Subject: Review of Site Investigation Report for the Former Trent Tube Property  
2811 Church Street, East Troy, Wisconsin BRRTS #02-65-245827

The Department of Natural Resources (Department) reviewed the "Site Investigation Report" (Report) for the Former Trent Tube Property in East Troy, Wisconsin (Property). The Report was prepared on your behalf by GZA GeoEnvironmental Inc. (GZA) and submitted to the Department on EnPro Holdings, Inc.'s (EnPro) behalf on December 7, 2022. A Wis. Admin Code ch. NR 749 review fee was included with the submittal. The nature of the Report and the complexity of the varied environmental conditions at the Property necessitated an extended review time.

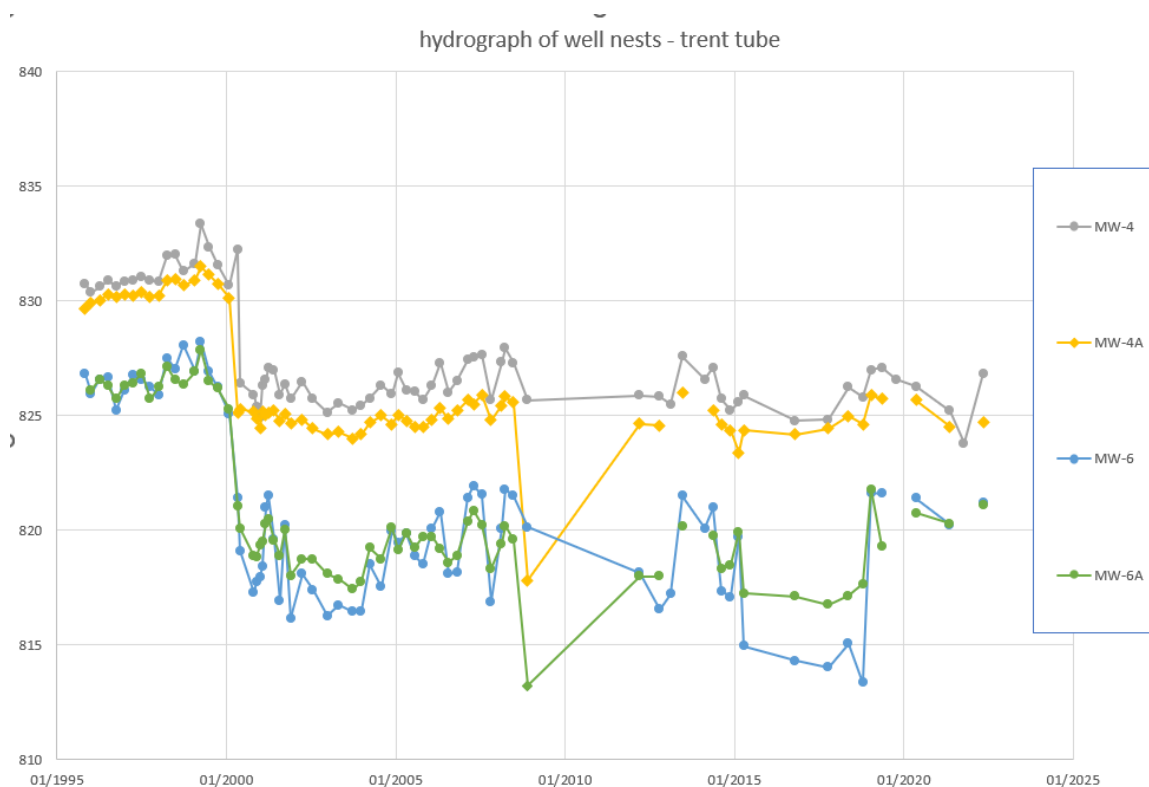
The radial flow pattern shown on the water table maps does not mesh with the simplified version of groundwater flow presented in the Geology Section of the Report. The groundwater mound or divide shown near monitoring well MW-17R is suggestive of downward vertical gradients. The potential affects of the groundwater mound or divide on groundwater flow and contaminant transport need to be explained.
